NEW HAMPSHIRE
DEPARTMENT OF PUBLIC WORKS AND HIGHWAYS
AND
STATE OF MAINE - DEPARTMENT OF TRANSPORTATION
INTERSTATE 95 BRIDGE
OVER
PISCATAQUA RIVER
BETWEEN
PORTSMOUTH, NEW HAMPSHIRE AND KITTERY, MAINE

STATE OF MAINE
DEPARTMENT OF TRANSPORTATION
☐ Approved ☒ Returned for Corrections
APR 12 1977
☐ Approved as noted
☐ Approved as noted - Resubmit ☐ Rejected
L. L. Roberts
ASST. BRIDGE DESIGN ENGR.

DESCRIPTION DRAIN EXTENSION LAYOUT
PROJECT I-95 PISCATAQUA RIVER BRIDGE
LOCATION PORTSMOUTH, N.H. & KITTERY, ME.
ARCHITECT N.H.D. of P.W.&H. / S. of M.D.O.T. / HARDESTY & HANOVER
CONTRACTOR CHERNAK-BREDBENNER CONSTR. INC.
PAINT
HOLES
DRAWN BY MARCO KM
CHECKED BY MARCO
DATE 2-1-77
PROJ. NO. 77-262
DRWG. NO. E1

DESCRIPTION TRUSS ELEVATION - DRAIN EXTENSION
PROJECT I-95 PISCATAQUA RIVER BRIDGE
LOCATION PORTSMOUTH N.H. & KITTERY, ME.
ARCHITECT N.H.D. of P.W. & H. / S. of M. D.O.T. / HARDESTY & HANOVER
CONTRACTOR CHERNAK-BREDBENNER CONSTR. CO.

DESCRIPTION DRAIN PIPE EXTENSIONS
PROJECT I-95 PISCATAQUA RIVER BRIDGE
LOCATION PORTSMOUTH, N.H. & KITTERY, MAINE
ARCHITECT N.H.D. of P.W.&H. / S. of H. DOT / HARDESTY & HANOVER
CONTRACTOR CHERNAK-BREDBENNER CONSTR. CO.

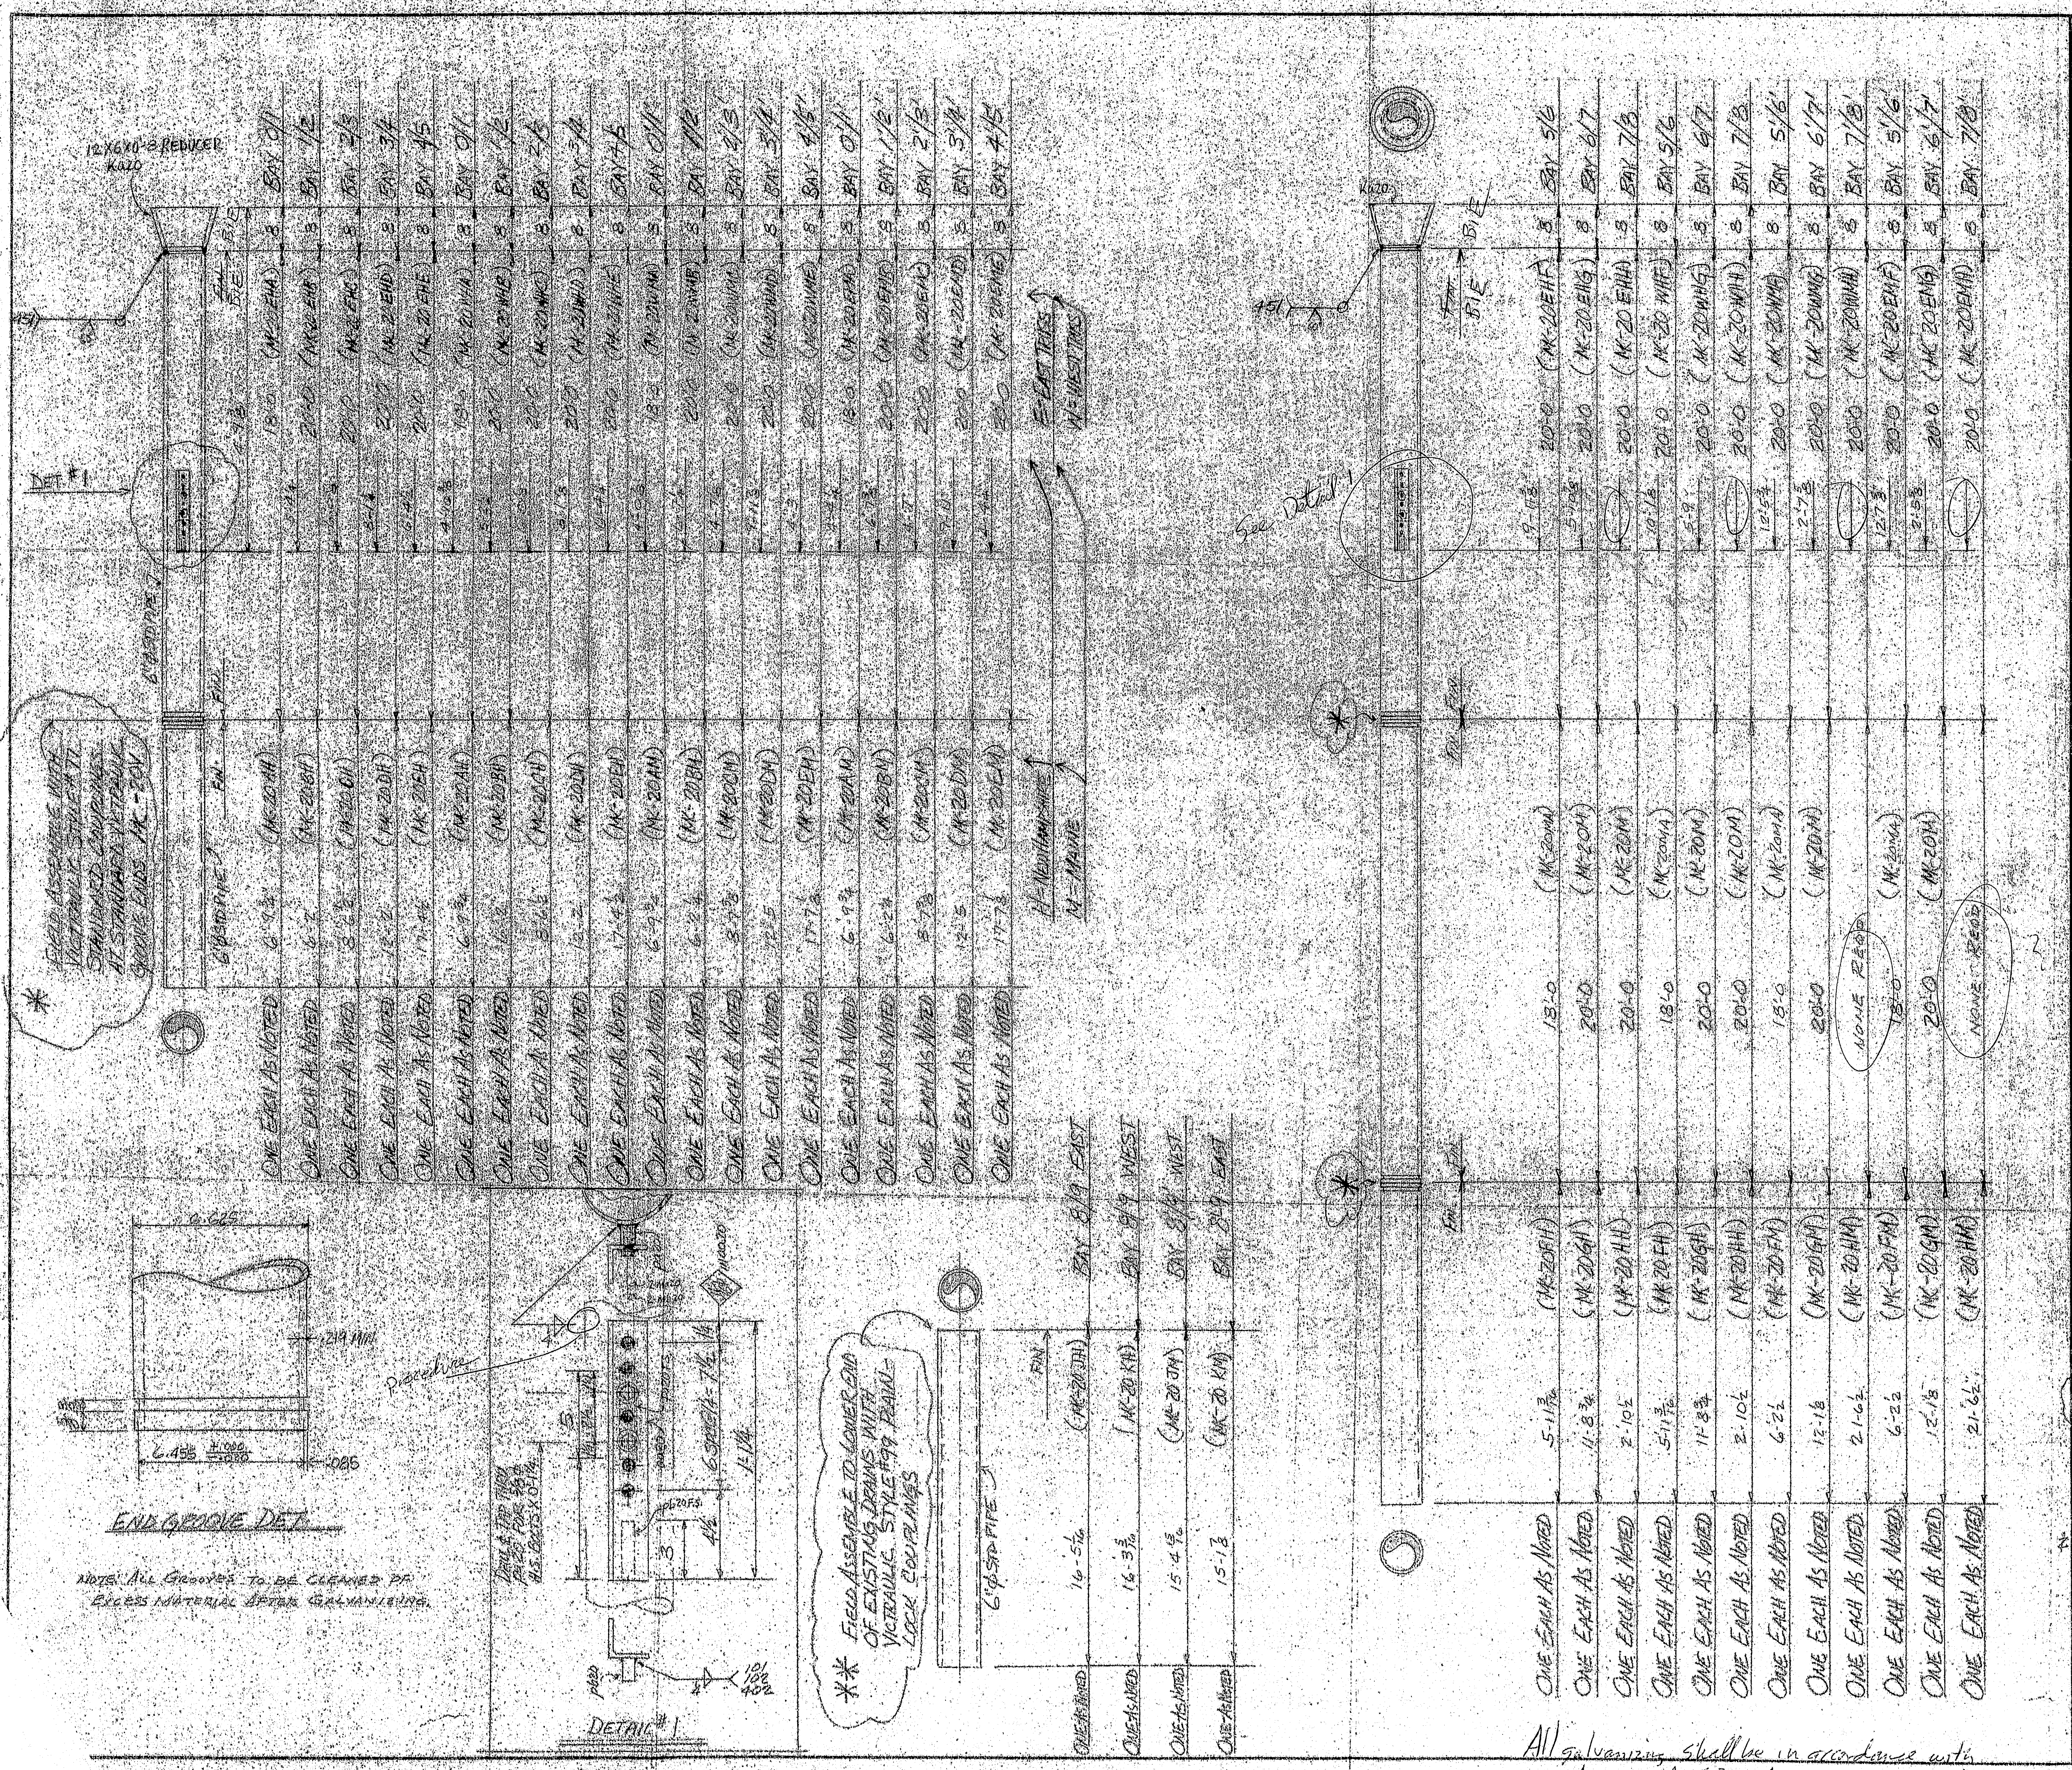
Gaskets Grade H

All galvanizing shall be in accordance with ASTM A153 & A123
